HISTORIC AND DESIGN REVIEW COMMISSION

July 20, 2022

HDRC CASE NO: 2022-334
COMMON NAME: 915 E CROCKETT
LEGAL DESCRIPTION: NCB 576 BLK 15B LOT 18 (CROCKETT ST)
ZONING: R-3, H
CITY COUNCIL DIST.: 2
DISTRICT: Dignowity Hill Historic District
APPLICANT: Jennifer Park
OWNER: Jennifer Park
TYPE OF WORK: Construction of a 2-story, single family residential structure
APPLICATION RECEIVED: May 31, 2022
60-DAY REVIEW: Not applicable due to City Council Emergency Orders
CASE MANAGER: Edward Hall

The applicant is requesting conceptual approval to construct a 2-story, single-family residential structure on the vacant lot at 915 E Crockett, located within the Dignowity Hill Historic District.

1 SITE PLAN
Scale: 1/8"=1'-0"

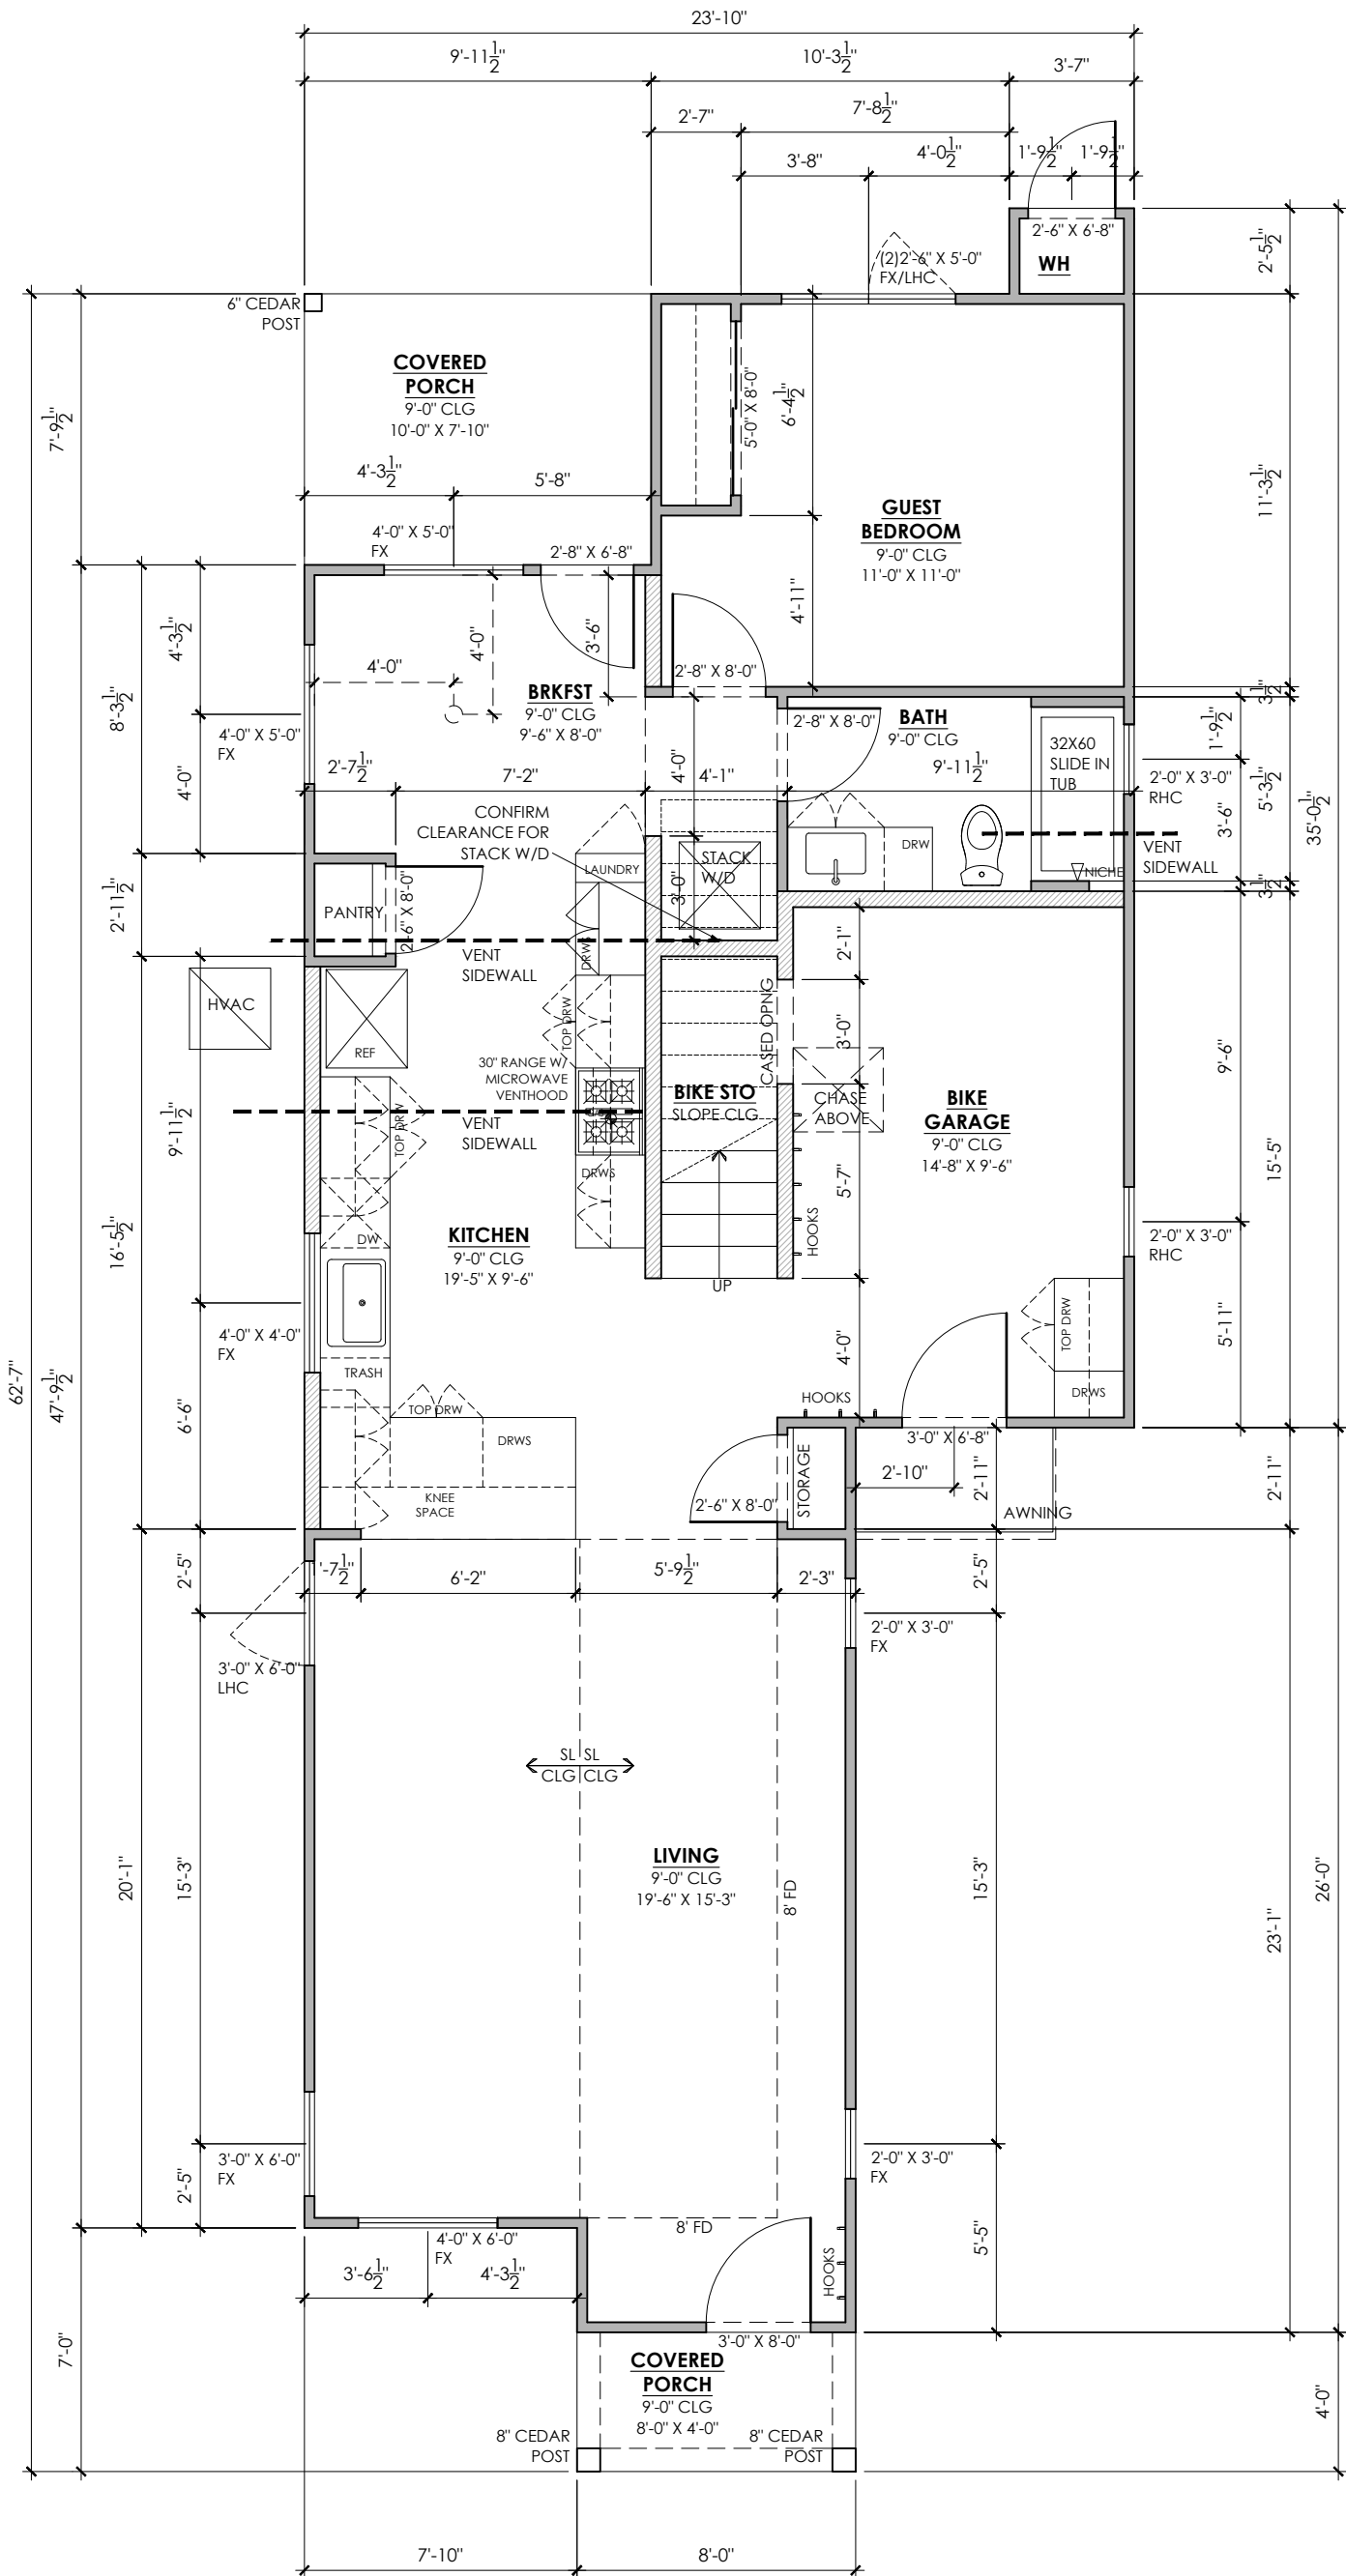
examples found on the block. The applicant has proposed a setback 10' – 2" from the front property line; however, the applicant has not specified the front setback at this time. Staff finds that the proposed setback should be equal to or greater than those found historically on the block. Matching the setback of the new construction at 919 E Crockett would be appropriate.

- i. LOT COVERAGE – Per the Guidelines, the building footprint for new construction should be no more than fifty (50) percent of the size of the total lot area. The proposed lot features .07 acres in size, or approximately, 3,050 square feet. The applicant has proposed a building footprint of approximately 1,141 square feet. Staff finds the proposed building to lot ratio to be appropriate.

- p. DRIVEWAY – The applicant has proposed to install a concrete driveway that would result in the driveway terminating in front of a portion of the massing of the historic structure. Historically, driveways within the Dignowity Hill Historic District are located completely to the side of the primary structure on the lot. Staff finds

the proposed location to be appropriate provided the applicant separate the concrete from the house via a landscaped area. The proposed driveway should not exceed ten (10) feet in width.

- i. That the applicant confirm that the proposed new construction will feature a setback that is equal to or greater than those found historically on this block, as noted in finding d. A setback that matches that of the new construction at 919 E Crockett would be appropriate, as this setback is consistent with the Guidelines.

- viii. That the proposed driveway be separated from the proposed new construction by a landscaping strip, and be no more than ten (10) feet in width.

1 FLOOR PLAN
Scale: 3/16"=1'-0"

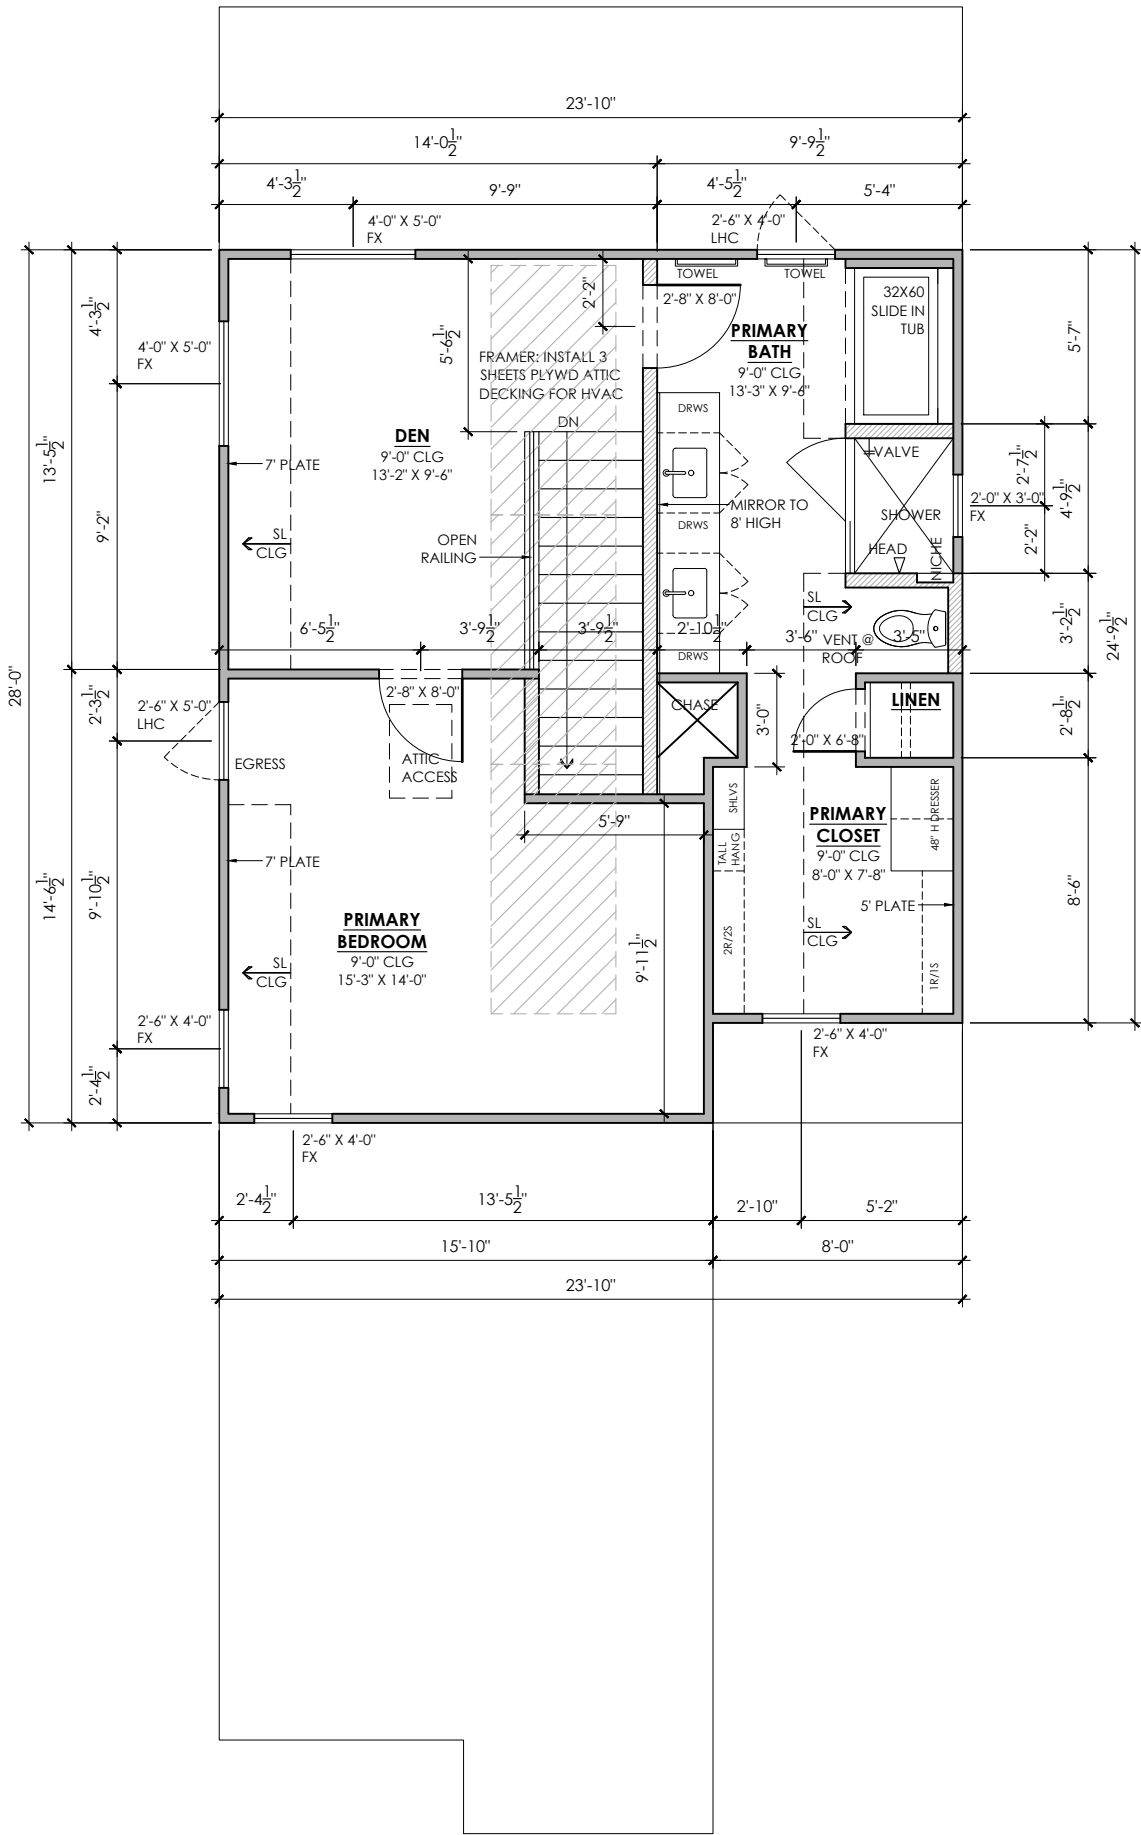
- m. PORCH – The applicant has proposed a front porch that features distinct massing and form. Generally, staff finds the proposed porch to be appropriate and consistent with the Guidelines. Staff finds that columns should be six inches square with capital and base trim.

- vi. That the proposed porch columns be six (6) inches square and feature capital and base trim.
- vii. That the applicant develop a detailed landscaping plan that notes the installation of landscaping materials, includes a front walkway, as noted in finding q, and includes any fencing plans, as noted in finding o.

1 FRONT ELEVATION - SOUTH

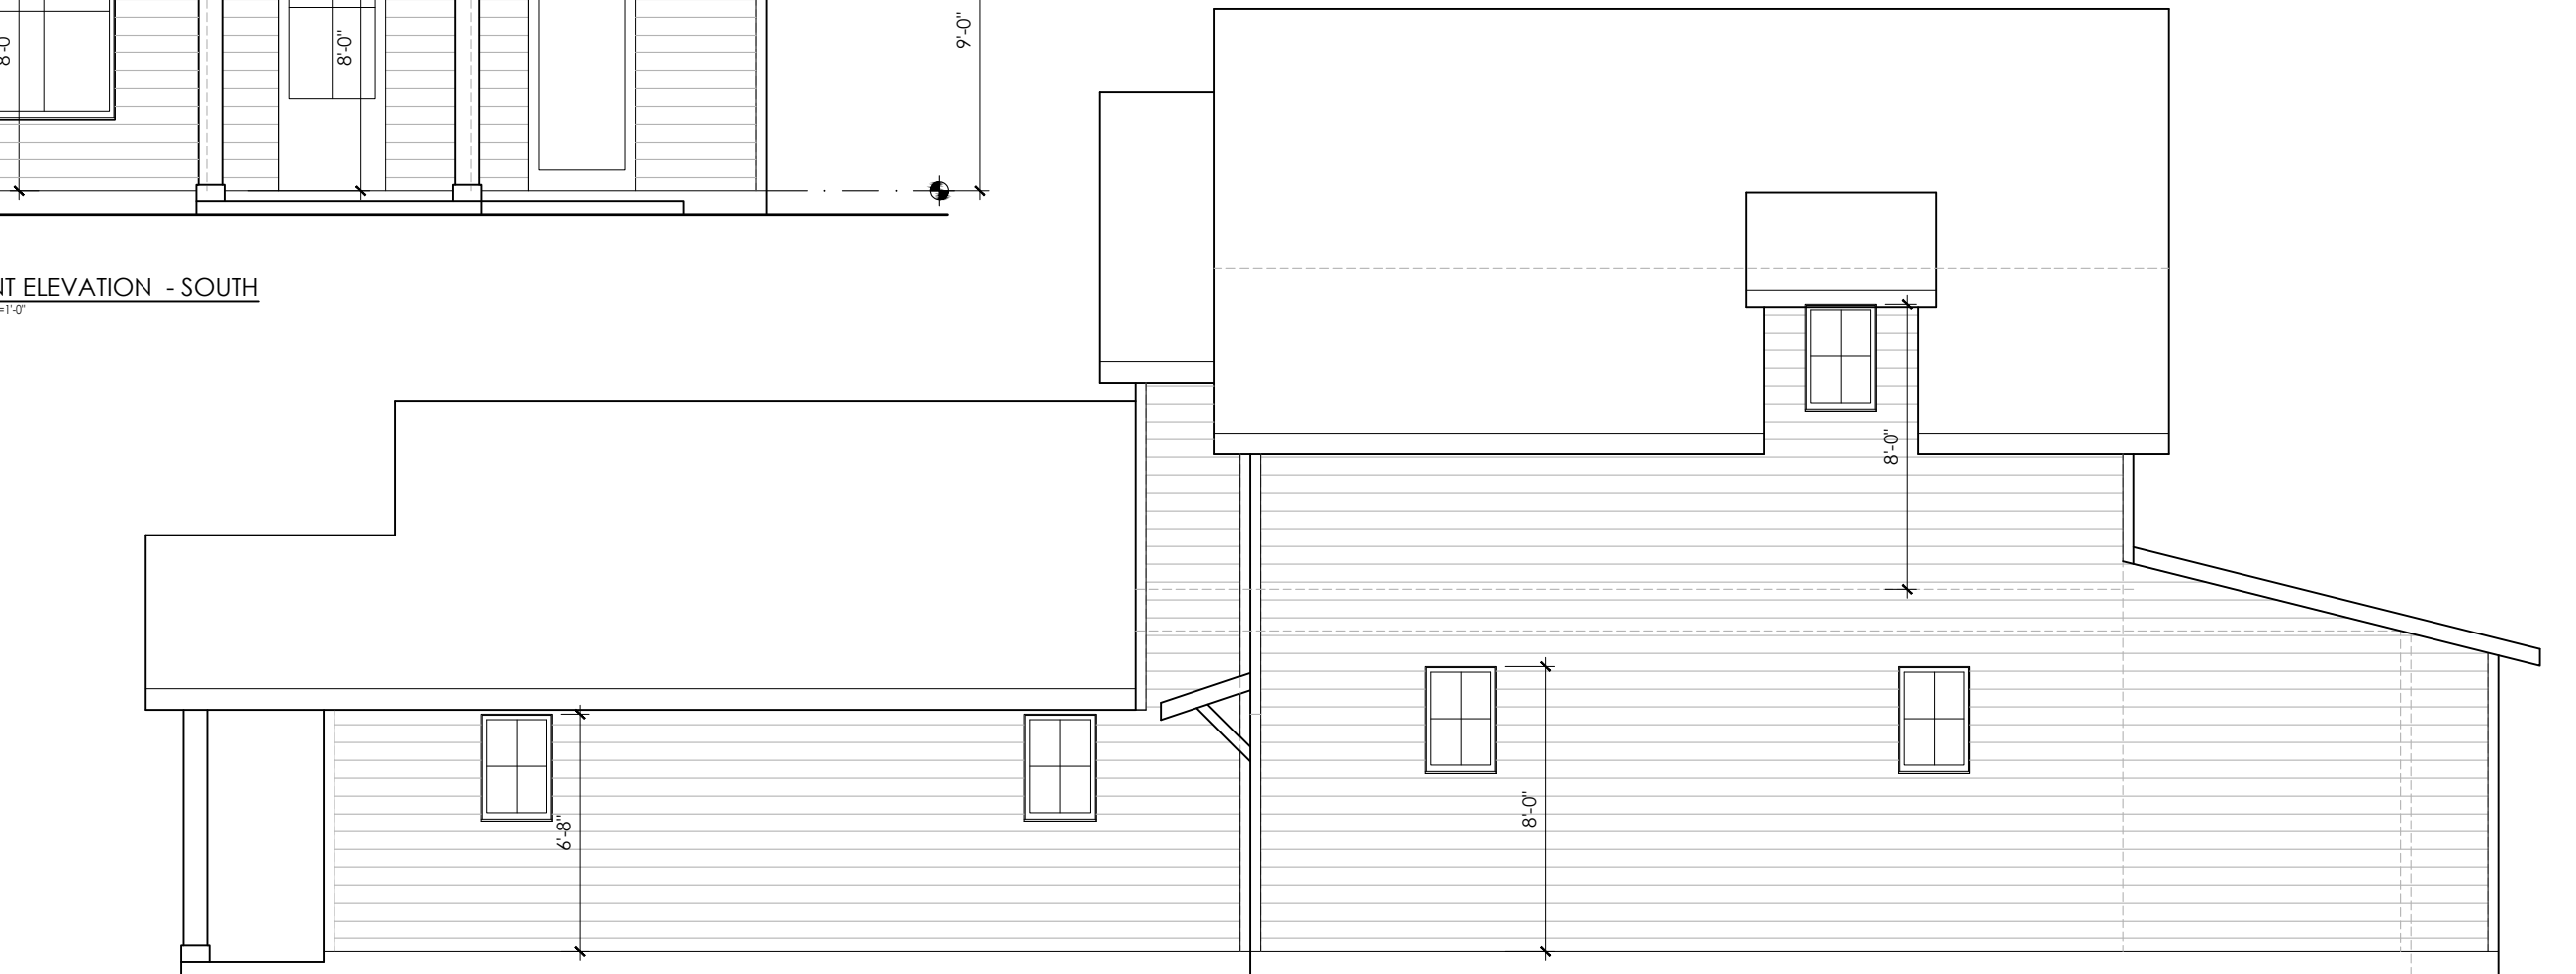
- g. FOUNDATION & FLOOR HEIGHTS – According to the Guidelines for New Construction 2.A.iii., foundation and floor heights should be aligned within one (1) foot of neighboring structure's foundation and floor heights. Historic structures on this block feature foundation heights of approximately one (1) to two (2) feet in height. At this time the applicant has not specified a foundation height. Staff finds that a foundation height of at least one (1) foot should be incorporated into the design to be consistent with the Guidelines.

- h. ROOF FORM – The applicant has proposed for the new construction to feature a series of front facing gabled roofs. Front facing gabled roofs are found historically within the Dignowity Hill Historic District. Staff finds the proposed roof forms to be appropriate.

- l. FENESTRATION PROFILE – The applicant has proposed a series of window sizes that typically feature proportions that are atypical for those found historically within the district in residential construction. Generally, staff finds all window locations to be appropriate; however, staff finds that windows should feature a traditional profile (including both heights and widths). Grouped windows should be separated by a mullion of at least six (6) inches in height.

- ii. That the applicant incorporate a foundation height of at least one (1) foot in height, as noted in finding g.
- iii. That if composite siding is installed, it feature a smooth finish and an exposure of four (4) inches. Board and batten siding should feature smooth boards that are approximately 12 inches in width with battens that are approximately 1.5 inches in width. Metal and shingle roofing are both appropriate; however, metal roofing should feature smooth panels that are 18 to 21 inches in width, seams that are 1 to 2 inches in height, a crimped ridge seam or a low profile ridge cap and a standard galvalume finish.

- v. That the applicant revise the proposed fenestration profile as noted in finding l. Windows and their openings should feature traditional sizes and profiles. Grouped windows should be separated by a mullion of at least six (6) inches in width.
